## PEUGEOT/CITROËN THERMOSTAT **REDESIGN TO OVERCOME OVERHEATING ISSUES**

Issue Date: 23/09/19 Issue Number: COTB0026B

APPLICATION: Citroën C4, DS3, Peugeot 207, 3008, 308, 5008, RCZ

APPLICABLE REFERENCES: BBT396 / BBT477

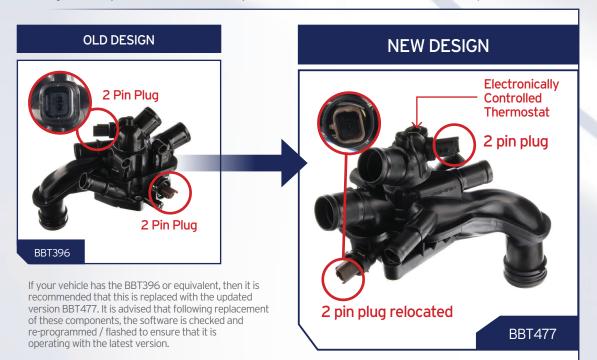
Due to an increase in overheating issues & symptoms such as an erratic temperature gauge, erratic running, radiator fan run-on, or poor heater function in the above vehicles, the O.E.M. have modified the design of the Thermostat housing. Following the O.E. specification, we have replaced the old design BBT396 with the new latest design BBT477. The latest design benefits from an electronically controlled thermostat, a reinforced structure, and a new configuration of sensors.

We have highlighted the key differences below so that you are clear that the latest part; although visually different to what may be on the vehicle, is in fact the correct product.

The modified version has had the lower 2 Pin connector relocated, therefore, a new cable may also be required to carry out the modification.

New Cable: BTS3091 - Thermostat Wiring Harness
